Access Compliance Report

Public Rights-of-Way

(Curb Ramps)

Intersection ID: 23437	Main Street: TRYON_ST	Cross Street: MOSS_LN	Location: W
ADA ID: D4B7C8984A9E	Ramp Type: MedianPerp	Initial Pass/Fail: Fail	Overall Compliance: No
Codes/Mitigation Info/Possible Solution		Field Measurements/Component Compliance	
Severity Score: 12.5

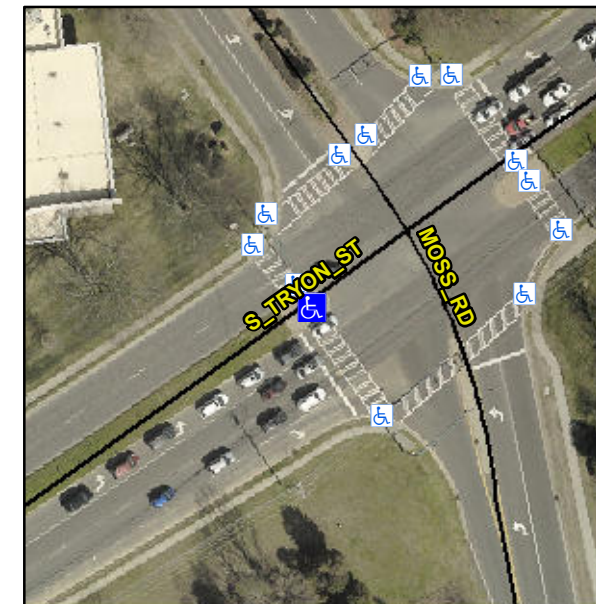
Not Found, R304.2.2

Compliance	Description	Data	Compliance	Description	Data
N/A	Ramp Length (in)	48.0	No	Ramp Slope (%)	9.8
Yes	Ramp Width (in)	48.0	Yes	Ramp XSlope (%)	0.5
N/A	Flare Type LT	N/A	N/A	Flare Type RT	N/A
N/A	Flare Slope LT (%)	N/A	N/A	Flare Slope RT (%)	N/A
N/A	Flare Traversable LT?	N/A	N/A	Flare Traversable RT?	N/A
N/A	Landing Length (in)	N/A	N/A	DWS Provided?	N/A
N/A	Landing Width (in)	N/A	N/A	DWS Contrast?	N/A
N/A	Landing Slope (%)	N/A	N/A	DWS Length (in)	N/A
N/A	Landing X Slope (%)	N/A	N/A	DWS Full Width?	N/A
N/A	Landing Curb? (Y/N)	N/A	N/A	DWS Offset (in)	N/A
N/A	Shared Landing?	N/A			
N/A	Gutter Ponding?	N/A	N/A	Gutter Slope (%)	N/A
N/A	Gutter Lip Ht (in)	N/A	N/A	Gutter X Slope (%)	N/A
N/A	Painted X Walk1?	Yes	N/A	Painted X Walk2?	N/A
	X Walk 1 Direction	To SE		X Walk 2 Direction	N/A
N/A	X Walk 1 Width (in)	119.0	N/A	X Walk 2 Width (in)	N/A
	X Walk 1 Slope (%)	3.1		X Walk 2 Slope (%)	N/A
	X Walk 1 X Slope (%)	1.1		X Walk 2 X Slope (%)	N/A

Remove & Replace Entire Ramp.
